Proposal for SAS 2.x Specification to Enable Support for Active Cables

QUELLAN

May 2, 2008

List of Proposed Modifications to SAS 2.0 to Enable Active Cables

Figure 98 — Mini SAS 4x cable plug connector that attaches to an enclosure universal port

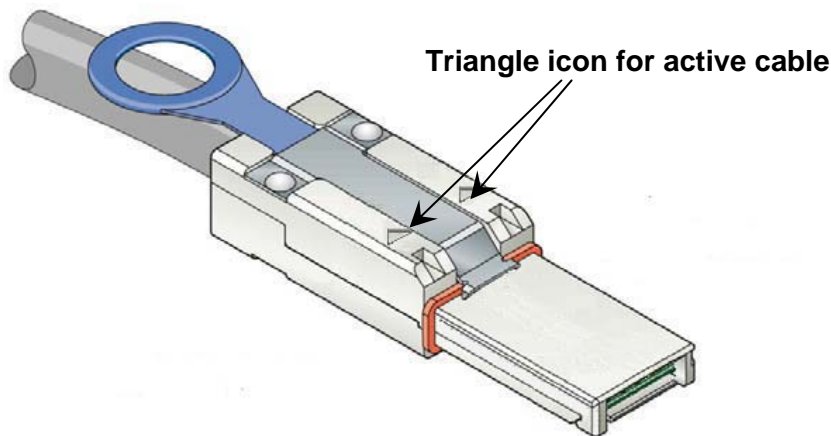
In order to ensure that active cables cannot be plugged into legacy (passive) ports, differentiating keying shall be provided by removing all the key slots from the plug connector and all the keys on the receptacle connector. In addition, two triangle icons on each side on the plug connector will be added to the plug connector to distinguish an active cable assembly (Figure 98).

Figure 98 shows an active mini SAS 4x cable plug connector that attaches to an enclosure universal port:
